Re: Initial Submission Review: Parklands Village 2 Phase 3 – Site Plan and Plat
Application Number: DA-2289-04
Case Numbers: 2024-4012-00; 2024-3014-00

Initial Submission Review

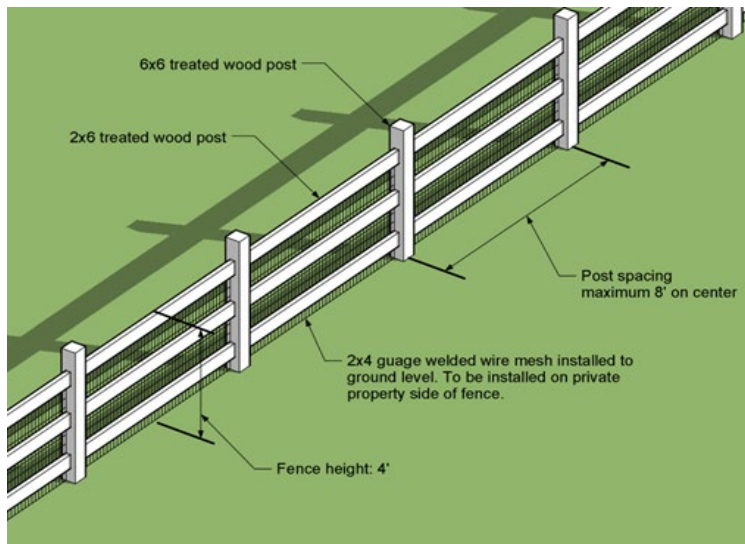
3K. Sheet 58: Are fences proposed for the townhome units?

Sheet 58: Update line weights, the location of 3-rail fencing and interior lot fencing is unclear.

Sheet 58: It appears that solid fencing is proposed on open space, pedestrian connections, and backing to the park. Per the master plan (page 94) "Open rail fencing will be used along open space areas. Powder coated metal fencing should be used at amenity spaces and pool enclosures." UDO 4.7.9.K.1 also states, "fences adjacent to public parks, open space, trails, and drainage ways shall meet the design standards shown in Figure 4.7-37." See image below. Please revise all fences bordering parks and open space to be open-style.
